City of Pryor Creek -Bond Issue 2018 Police/Fire Energency and City Library

# Pryor Emergency Services Center & Library Renovation Project Monthly OAC Meeting Thursday, December 16th, 2021

Project: 1903a Pryor Police/Fire Emergency Services Center and Library Additions

# Proposal Request #03 : Site Plan Storage Bldg Changes

#### P1.1

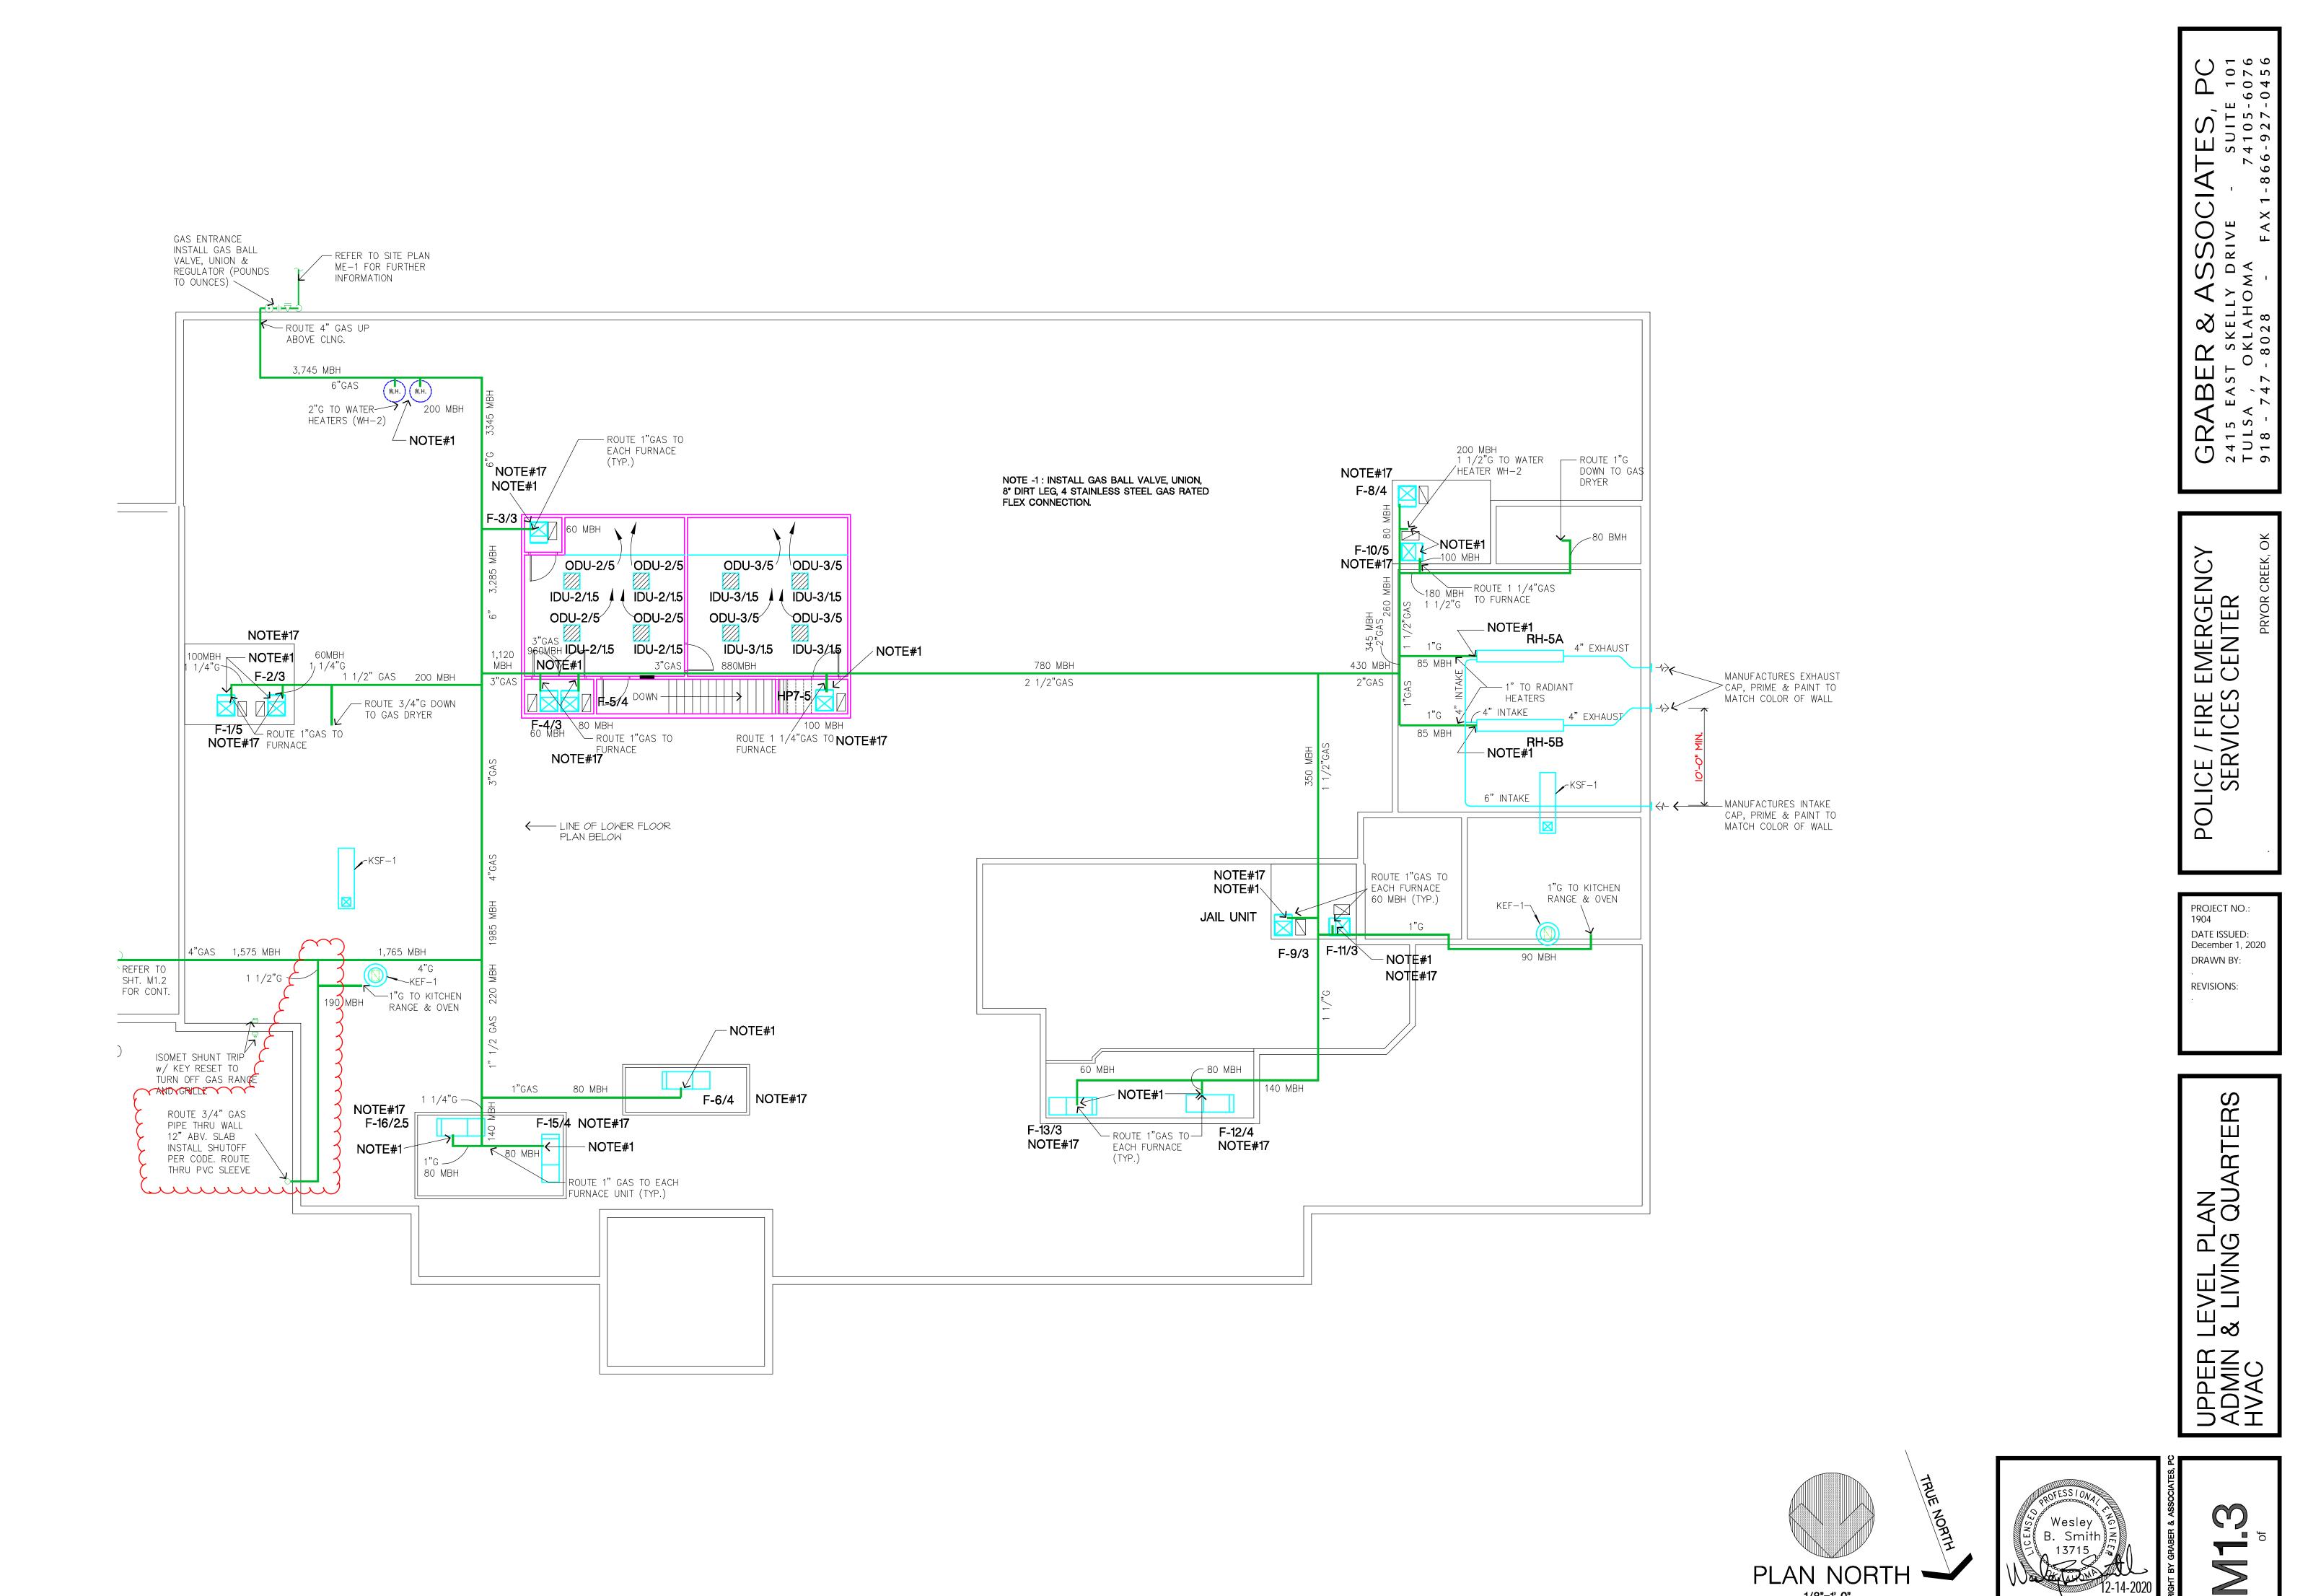
- Remove hot and cold water line at deleted sink in Conference Room 163.

- Remove vent for deleted sink in Conference Room 163. Underground sanitary line already installed. Abandon in place.

#### LM.E1

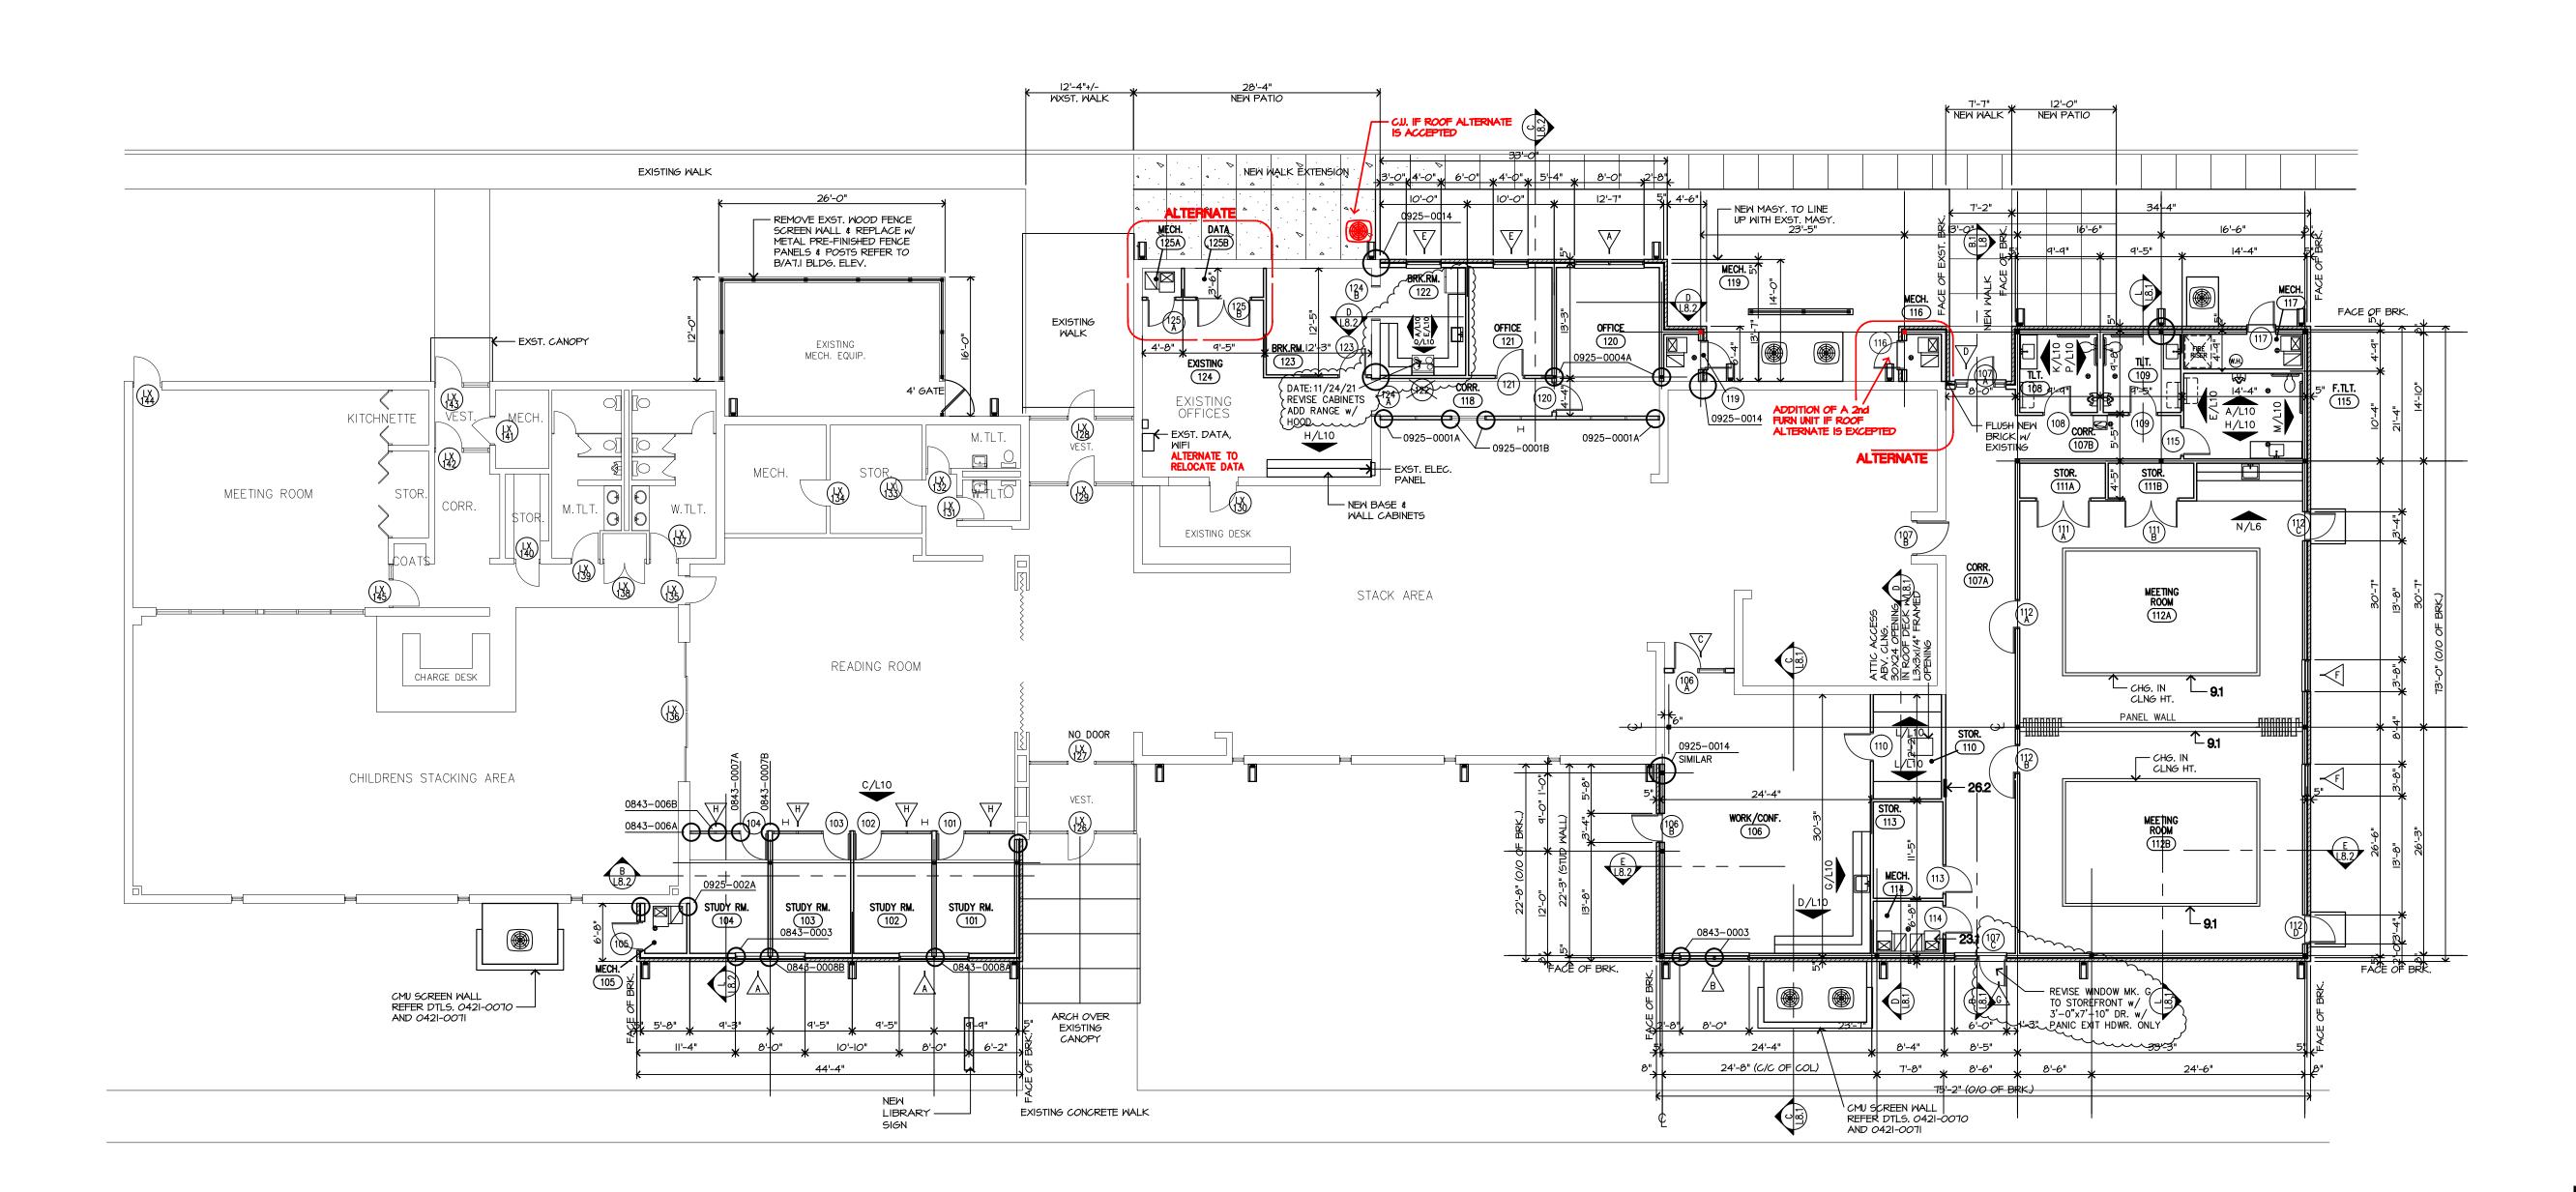
- Added circuiting information to light fixtures.
